June 20, 2016

Town of Newburgh Zoning Board of Appeals
Town of Newburgh Planning Board

RE: Cumberland Farms Inc.
270 Route 17K
Town of Newburgh, NY

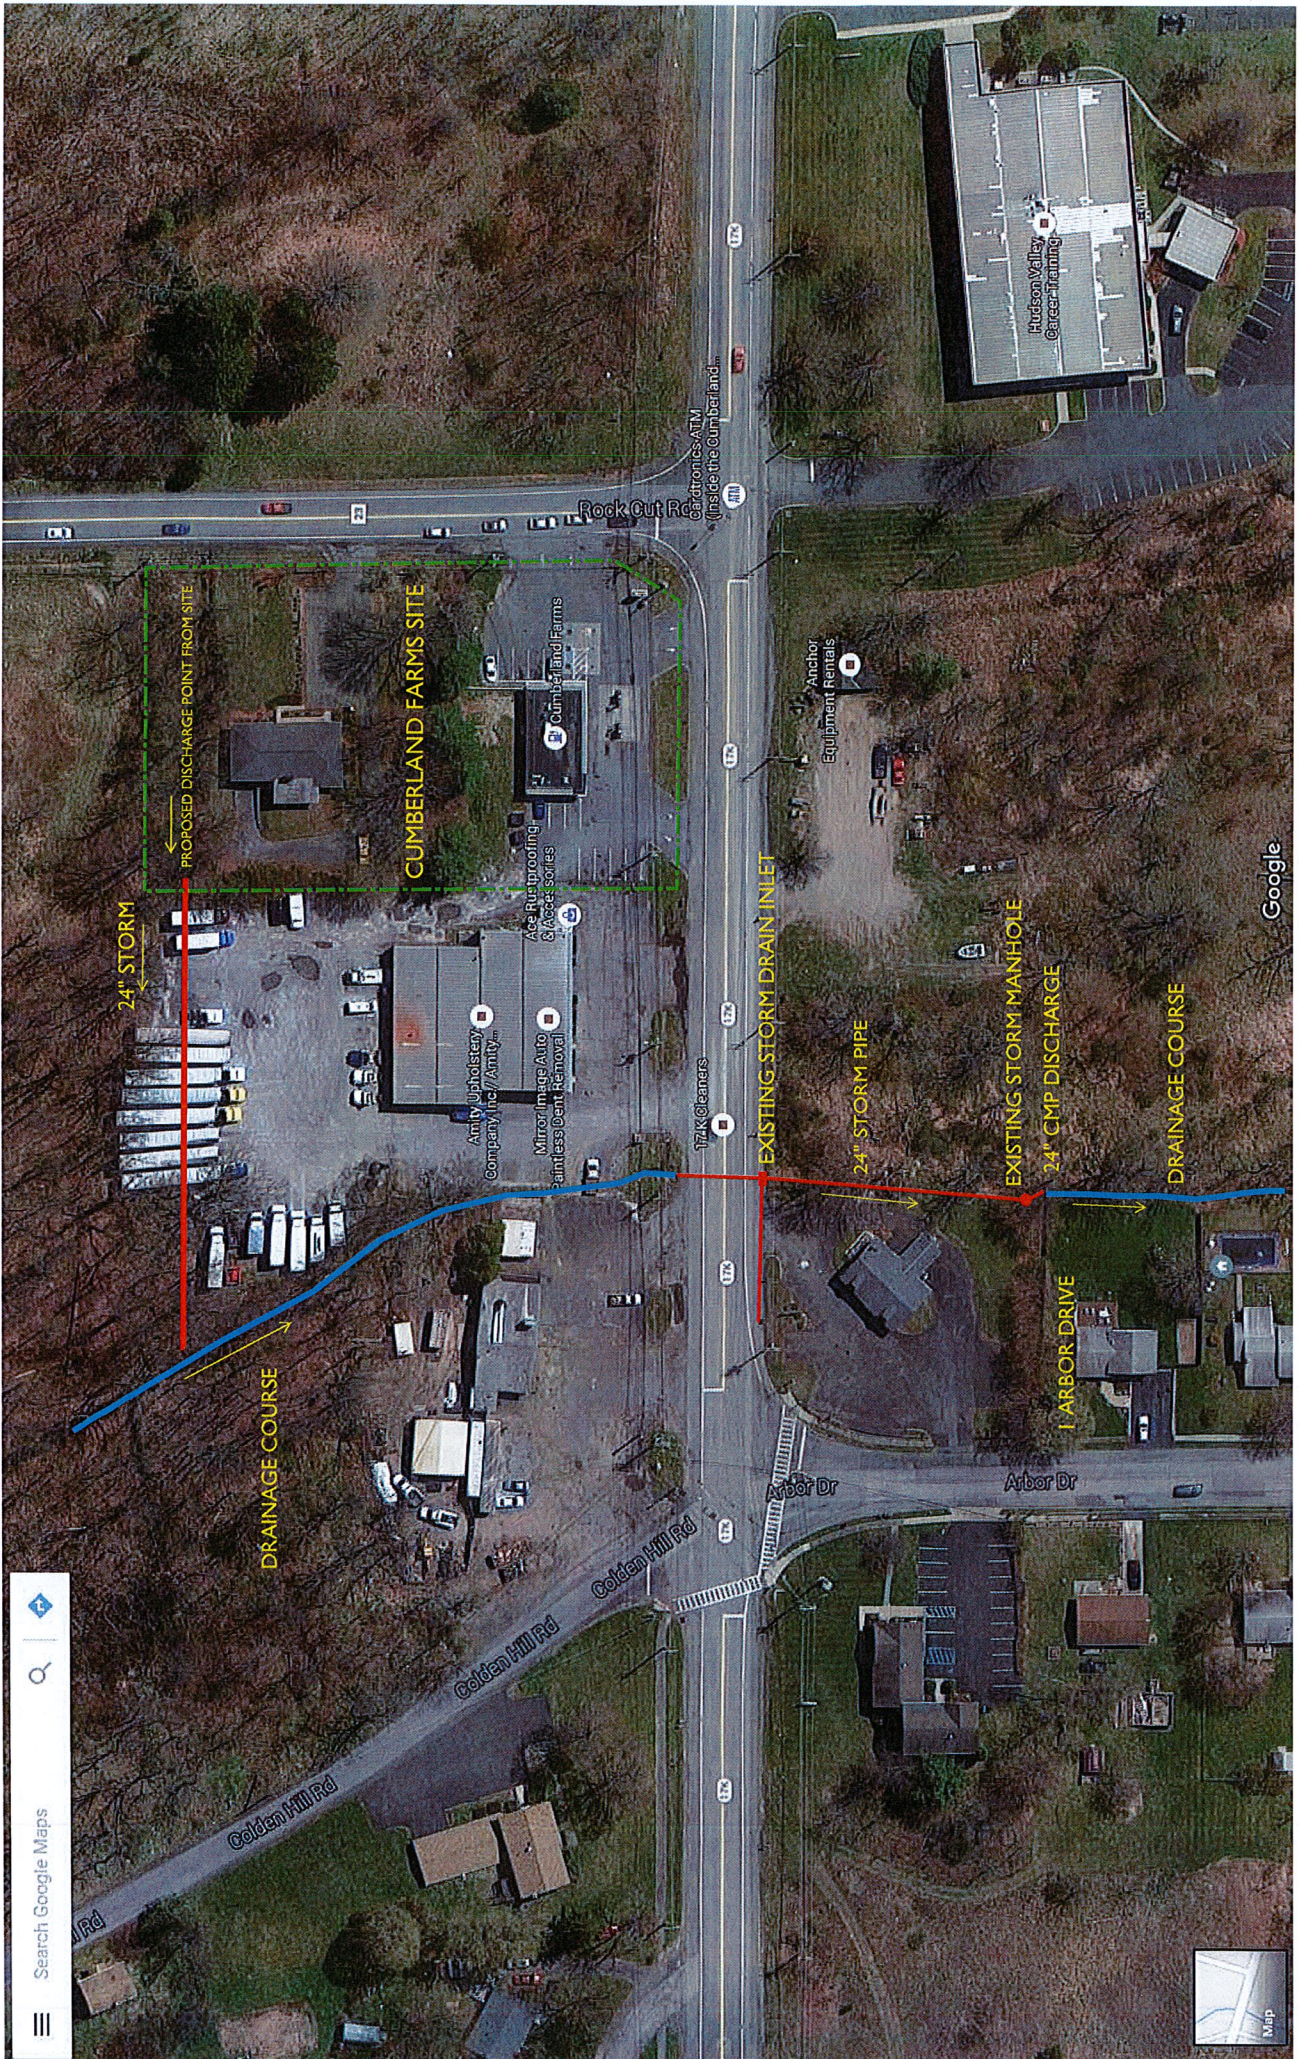
I do have concern with the existing storm drainage that the proposed project ties into. Attached is a sketch for reference. From what I can see on the site plan the project proposes its discharge point at the northwesterly corner of their site. The stormwater then appears to flow west under the Ace Rustproofing property where it discharges into a drainage course. This drainage course flows towards NYS Route 17K then into the state drainage system where it enters a piped system. This stormwater is piped through the 17K Cleaners property to a manhole, then to an end section that discharges at the northwest corner of my property.

As you can see in the attached photos the storm system which is intended to discharge has a few issues. Even during normal rain events I witness the storm manhole overtopping and draining onto my lawn (see attached photo of erosion at storm structure). The end section where the stormwater is discharged is also half buried. This causes erosion on my property due to the structure over topping and scour from the constant high flow discharge. I believe the storm system on the 17K Cleaners property lies within a NYSDOT drainage easement as they are connected to and accept storm drainage from NYS Route 17K. I do not want to see this issue get worse and feel something should be done.

I respectfully request that the receiving drainage systems be inspected and that the system be analyzed from the point of connection to the point of free discharge on my property. This is to prove all existing storm pipes, structures and discharge point have sufficient capacity to handle the proposed volumes and peak flows for all storm events that the proposed system is designed for. In addition the discharge point should have enough structural integrity to handle the constant high volumes and flows of stormwater.
